Community Based Resource Team FINAL Recommendations

US 321, Phase II, Buckhorn Road to SR 416

April 9, 2007

321 East Parkway / Phase II

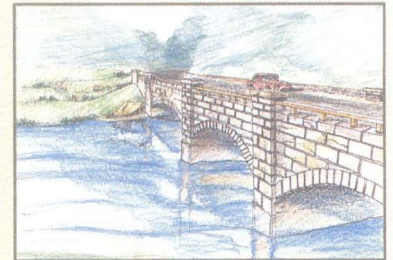
The CBRT recommends that Concept II be implemented, with the understanding that adjustments to the current concept may be required in the final design of the project. In order to ensure that the integrity of the design concept is being carried out, we ask that the resource team be included in the review process as the project moves through design and construction.

The final placement of the median crossovers and the median width at any given location may need to be somewhat different than shown on the concept. As Concept II is implemented, it is the strong desire of the CBRT that the introduction of provisions for left-turn entrance/exit to/from any properties be absolutely prohibited, such that the median does not lose its intended purpose(s).

In any case, the CBRT recommends that median openings and the median width at any given location be generally as shown on Concept II.

- ✓ A bifurcated, or split, median should be utilized as illustrated in Concept II. This approach will insure that this road remains a scenic parkway by creating rhythmic sequences of curves and elevations and by preserving the pleasant view of the mountains and ridge tops. A wider and varying width median provides the opportunity for a more naturalistic landscape that more closely mimics the natural setting and blends the highway comfortably with the environment. It will have a "traffic calming" effect for more moderate speeds, and will provide for limited access with development occurring in clusters at appropriate locations, as opposed to continuous strip development. With regard to the median element, both the "no build" and Concept I alternatives are traditional solutions and create a highway corridor that is "business as usual" and that are not appropriate in a parkway environment.
